East Wenatchee Water District	WATER SYSTEM STANDARD DETAIL
BACKFLOW PREVENTION ASSEMBLY	
File:EMD704 Revised: JAN 25, 2017 Printed: JAN 25, 2017	DRAWING NO. W-13 SHEET NO. 25

- REVISION HISTORY**
- JULY 2008**
- W-01 REMOVED NOTE DESCRIBING ACCESSORIES FOR VALVE BOXES. INFO IS NOW ON W-12.
 - W-02 ADDED KENNEDY KB1D AS AN APPROVED MODEL.

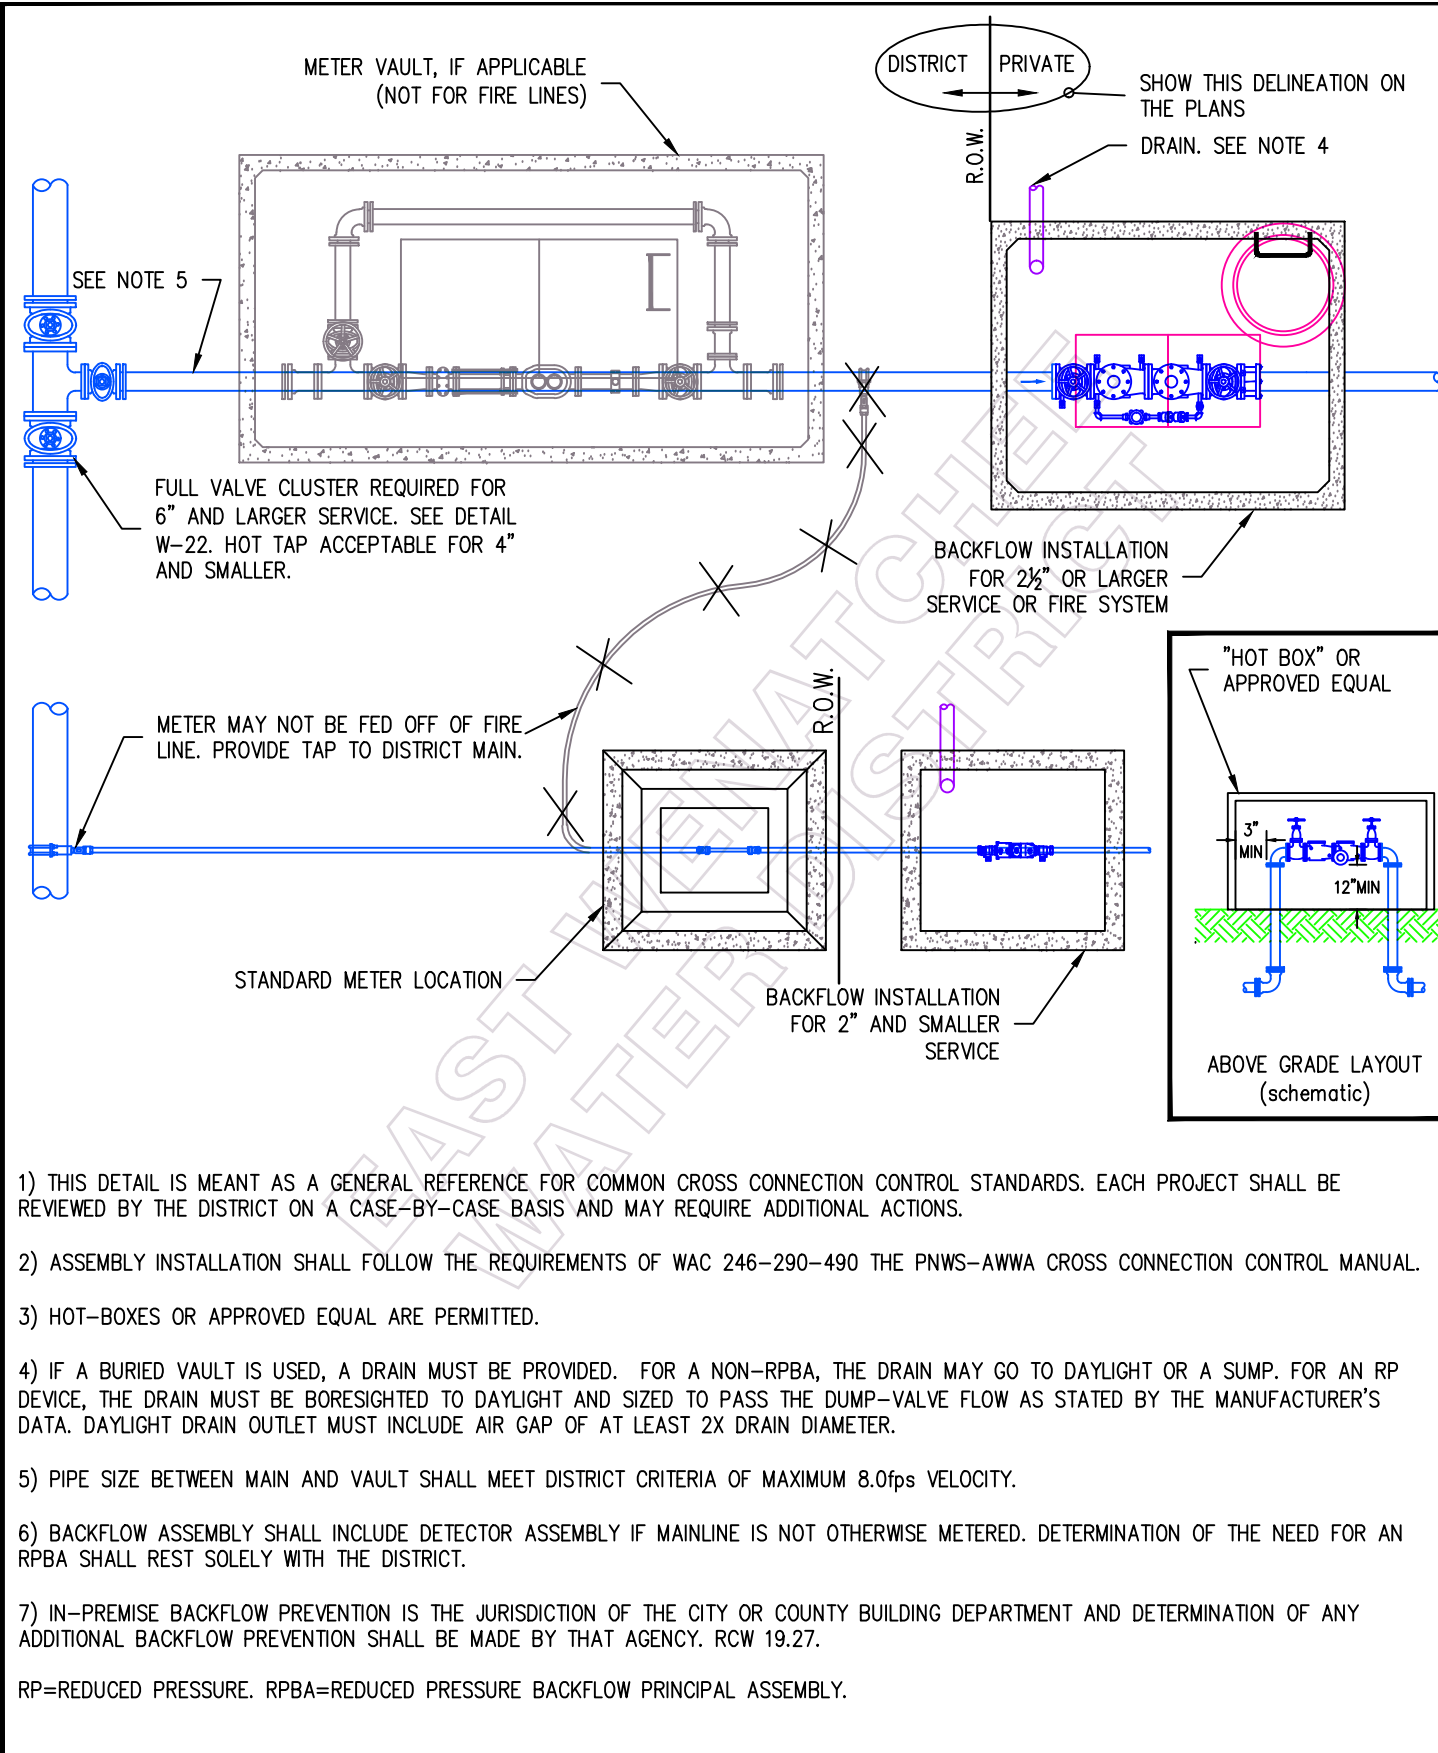
- W-24 ADDED LADDER-UP EXTENSION. ADDED NOTE 7 ON METER CAPACITY.
 - W-13 ADDED NOTE ON TEST COCK ORIENTATION. ADDED LADDER-UP EXTENSION. SPECIFIED BYPASS METER MODEL.

- W-04 UPDATED DOT SPEC NUMBER ON "CONSTRAINTS" NOTE #3.
 - W-12 ADDED NOTE TO SET LID BETWEEN 0" TO 1/4" BELOW PAVED SURFACE.
 - W-13 ADDED NOTE ON PIPE PASSING THROUGH VAULT WALL TO BE DI OR USE FLEX BOOT.

- W-12 ADDED WORDING ON NOTE 20 TO CLARIFY DI PIPE AS THE STANDARD. CONSISTENT WITH COMPREHENSIVE PLAN.
 - W-13 ADDED METER MODEL NUMBER "SR11".
 - W-01, W-30 CREATED SECOND CONSTRUCTION NOTES PAGE.

- W-10 SPECIFIED ALL PVC TO BE MINIMUM SCHEDULE 40.
 - W-13 DRAIN SIZE NOTE CHANGED TO 4" (MIN). RP DEVICES MAY NEED A LARGER DRAIN.
 - W-13 CHANGE BYPASS METER REGISTER MODEL FROM ECS TO TR/PL.

- W-13 REMOVED FLANGE PIPE ON INLET AND REPLACED WITH FCA.
 - W-14 ADD LOCATING TAP LABEL "BURIED WATERLINE".
 - W-15 REMOVED RESTRAINED VALVE NOTE. ADDED NOTE TO CUT SERVICE AT MAIN.

- W-12 ADDED DETAIL FOR CURB STOP RISER PIPE.
 - W-13 UPDATED BYPASS METER REGISTER MODEL.
 - W-14 ADDED CONCRETE BLOCKING AND PT WOOD SHIM CALLOUT.
 - CHANGED SERVICE LINE SIZE FOR 3/4" METER BASED ON WHICH SIDE OF THE STREET.

- JUNE 2015 (CONTINUED)**
- W-10 CHANGED VAULT LOCATION TO BE IN SIDEWALK.
 - W-13 REVISED VAULT DRAINS TO CONFORM TO DETAIL W-26.
 - W-15 REVISED FIRST PARAGRAPH.

- W-30 MOVED NOTE REGARDING SALVAGED EQUIPMENT TO DETAIL W-15.
- June 2016**
- W-13 REVISED MINIMUM VAULT SIZE REQUIREMENTS
 - W-13 REVISED SADDLE FIT RANGE

- W-13 UPDATED NOTE 3 TO CLARIFY RESTRAINED PIPE REQUIREMENTS
 - W-13 REMOVED THRUST BLOCKS AND SHACKLES
 - W-13 CHANGED THE FCA TO A FLxRJ ADAPTER
 - W-13 ADDED DISMANTLING JOINT

- W-13 UPDATED VAULT MIN INTERIOR DIMENSION REQUIREMENTS TO MATCH NEW PIPE LAYOUT
 - W-13 INCLUDED IPERL IN TYPE OF METER ALLOWED
 - W-15 INCLUDED AIR VALVE ASSEMBLIES IN WATER SERVICE SECTION TITLE

East Wenatchee Water District	WATER SYSTEM STANDARD DETAIL
BACKFLOW ASSEMBLY INSTALLATION	
File:EMD710 Revised: FEB 3, 2012 Printed: FEB 3, 2012	DRAWING NO. W-25 SHEET NO. 26

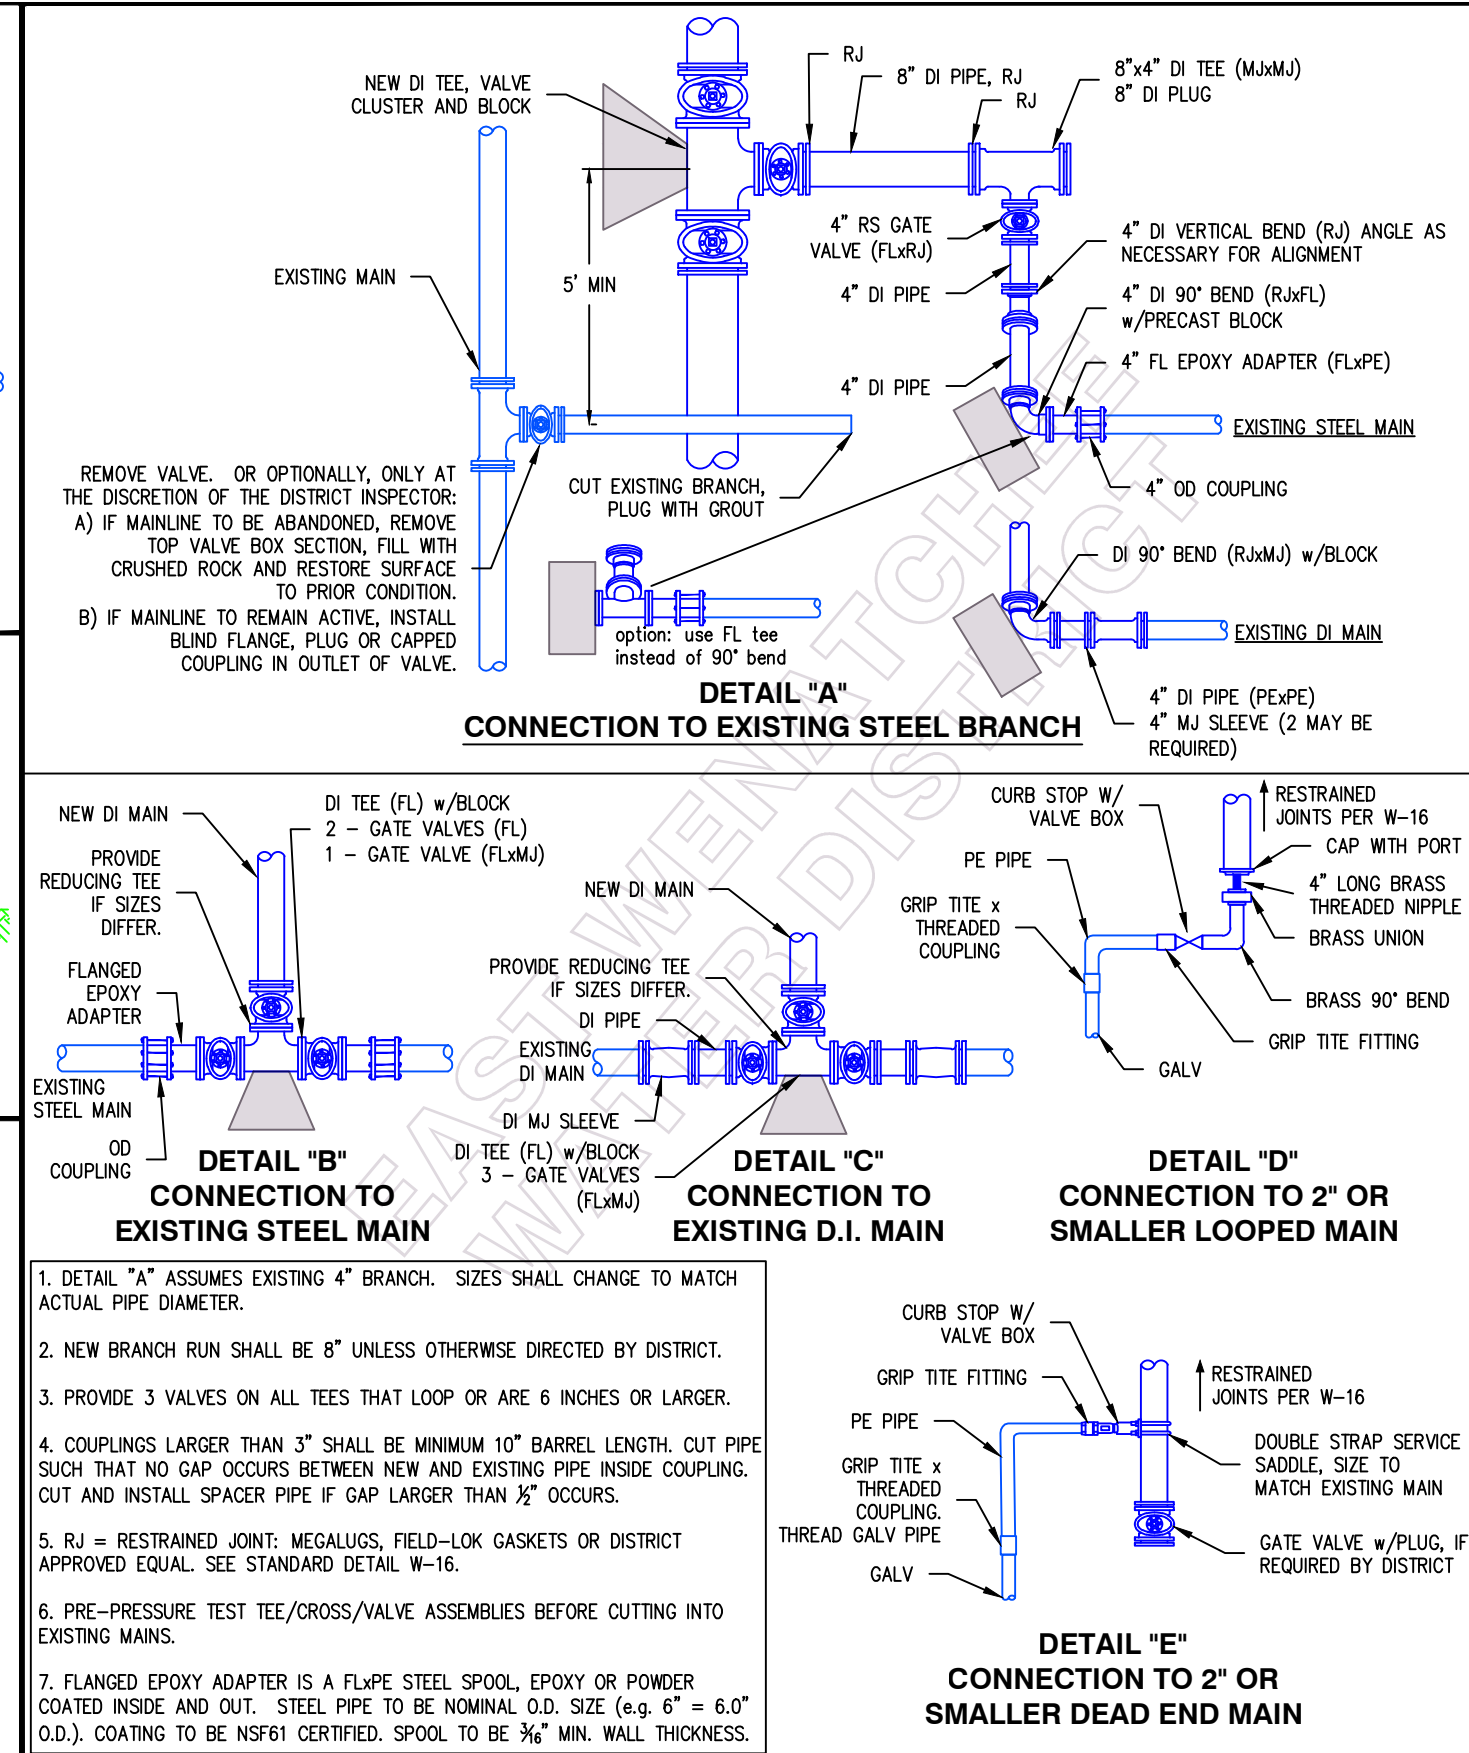
- DEC 2009**
- W-25 INCLUDED MINIMUM DIMENSION OF 3" FROM PIPE TO HOTBOX WALL, SAME AS STATE STANDARDS.
- JAN 2011**
- W-01 ADDED NOTE ON CASING AND RUNNER REQUIREMENTS.

- W-25 REMOVED NOTE THAT SAID DEVICE MAY BE LOCATED IN MECHANICAL ROOM. THIS IS NO LONGER PERMITTED AS THE SOLE METHOD OF BACKFLOW PROTECTION.
- OCT 2011**

East Wenatchee Water District	WATER SYSTEM STANDARD DETAIL
TRACER WIRE	
File:EMD703 Revised: JAN 25, 2017 Printed: JAN 25, 2017	DRAWING NO. W-31 SHEET NO. 29

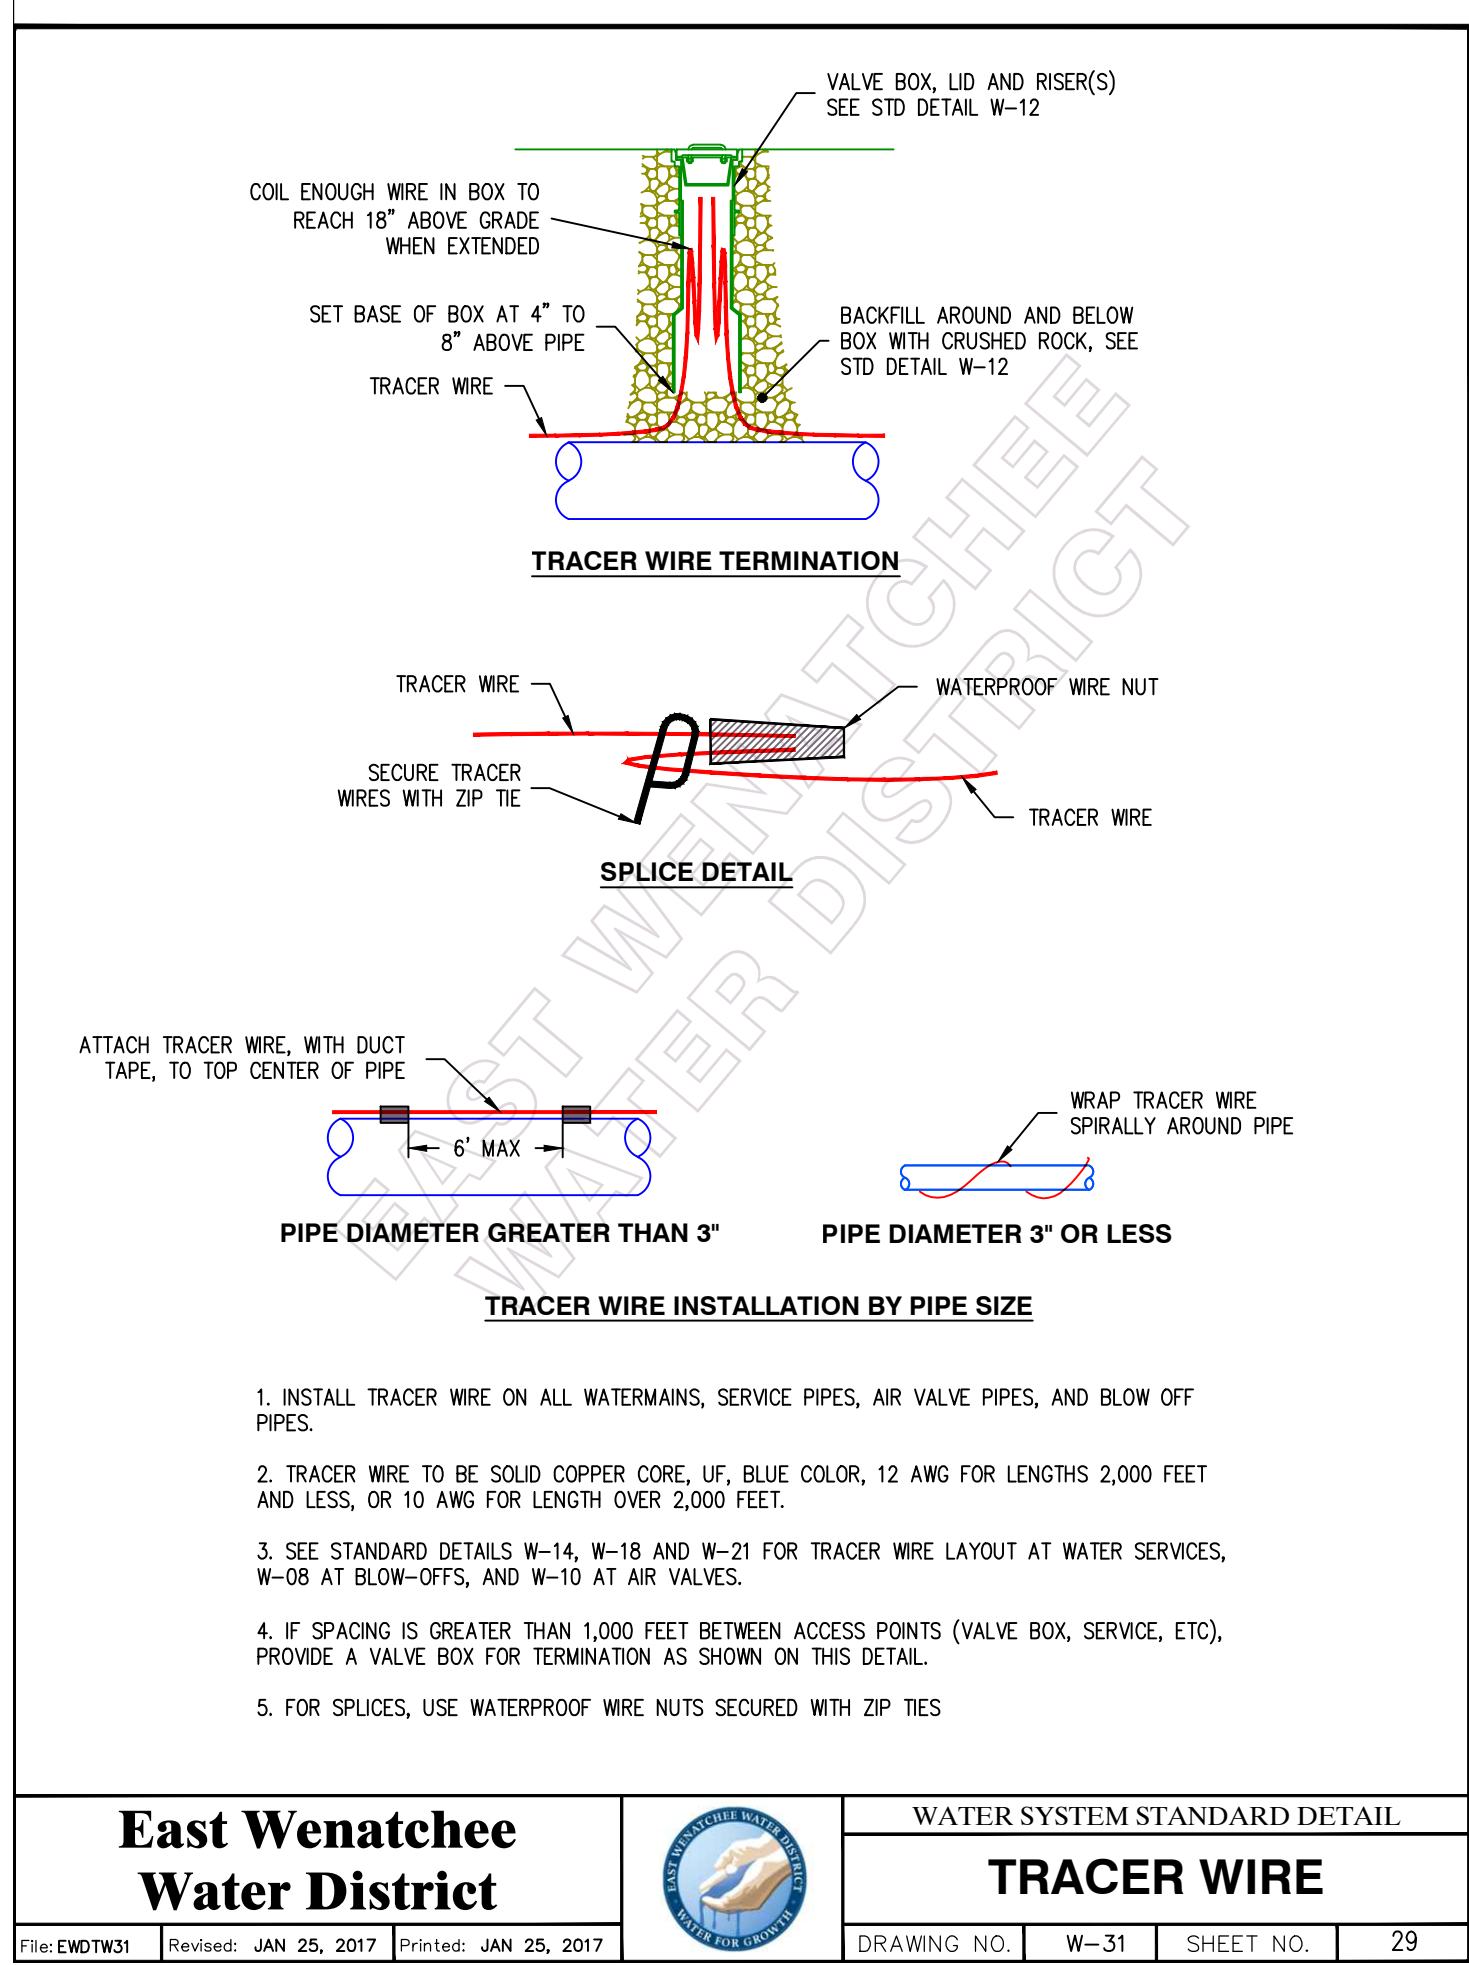
- W-31 NEW DETAIL CREATED FOR TRACER WIRE INSTALLATION
 - W-32 NEW DETAIL CREATED FOR CASING PIPES
- September 2017**
- W-01 RELOCATED DOMESTIC-MADE REQUIREMENT NOTE FROM NOTE 15 TO NOTE 1.
